## ADDENDUM 1

### 1.1 PROJECT INFORMATION

- A. Project Name: Lockefield, Bryce, Ott Hardscape Reparis
- B. Owner: The Trustees of Indiana University
- C. Owner Project Number: 20230562
- D. Landscape Architect: Landstory, Inc.
- E. Date of Addendum: May 27, 2025.

**L101**

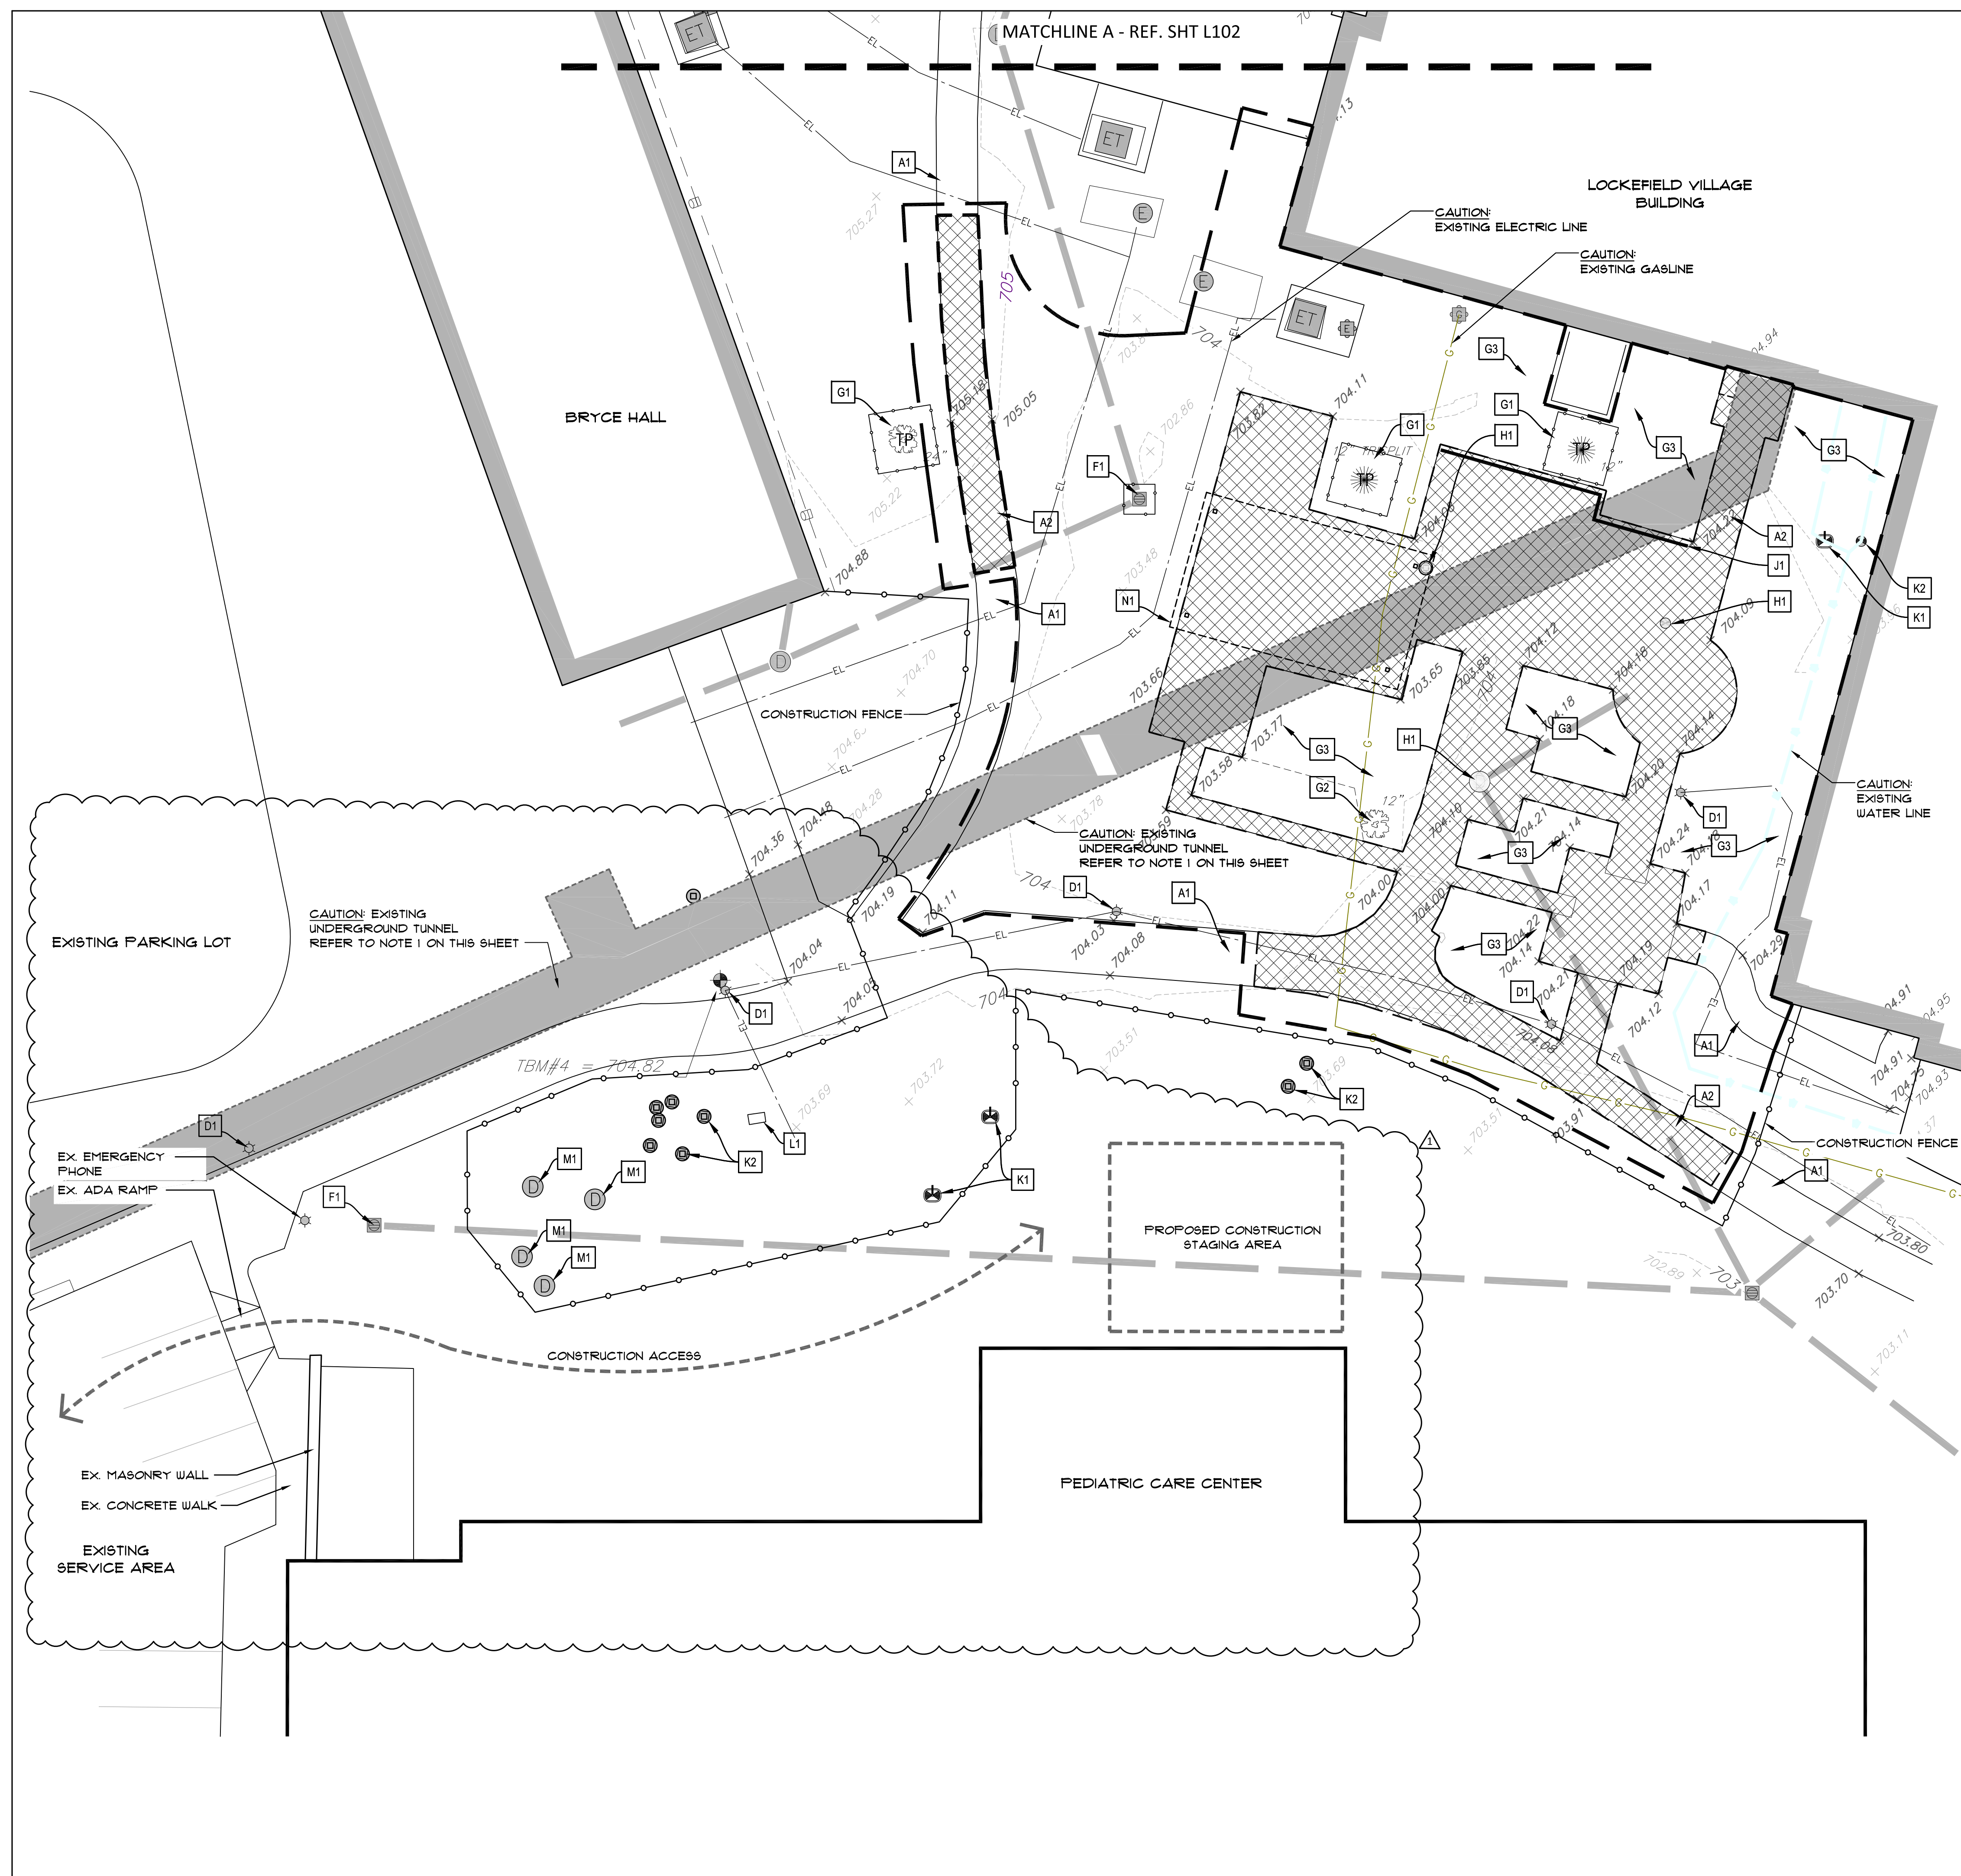
- A. Sheet L101 – “Demolition Plan” (reissued)
  1. Added construction staging area.
- B. Sheet ES202 – “Electrical Site Plan” (not reissued)
  1. Pullbox added to provide power to parking lot.
